Heavy Duty Tow Point 150 series Prado

Modified to Suit for TJM T13 Outback Bar

RP-PRA150

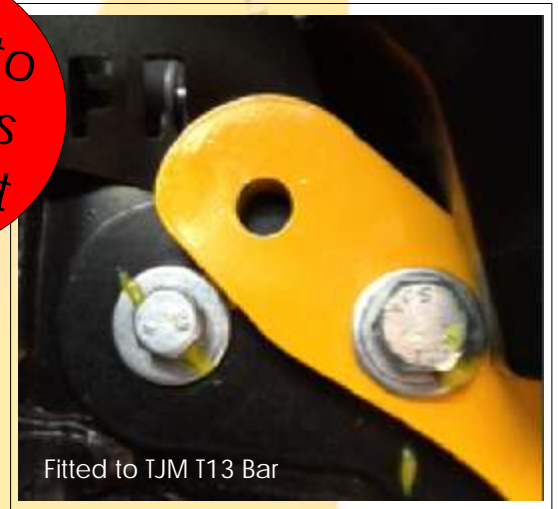
Due to customer fitment issues, we have modified the RP-PRA150 to suit for the TJM T13 Outback Bar. Due to this modification, the new destruction testing on the revised point resulted in a lower load to be applied before deformation. Subsequently the WLL on these points has been altered to 3250kgs per point. Due to the nature of the tow point components, and the way in which they could be used by untrained enthusiasts - safety is our highest priority. Setting a destruction tested WLL is a major part of encouraging safe use of these components within tested straight line pull load limits.

Rated to
3250kgs
per Point

Destruction
Tested to
9 tonne
